Access Compliance Report Public Rights-of-Way (Pedestrian Signals)

Main Street: VALENCIA_AVE Cross Street: ROSE_DR Location: NE

ADA ID: SGAT210920144129 Signal Type: One Push Button-APS Overall Compliance: No Severity Scores: BTN 1: 25 BTN 2: N/A No BTN: N/A

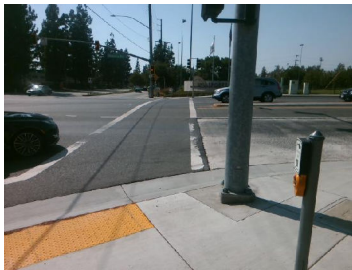
OC Std/PROW: MUTCD 4e.08, R404.2, R404.3

Possible Solutions: Replace Signal Push Button With APS Button. Remove & Relocate Sign.
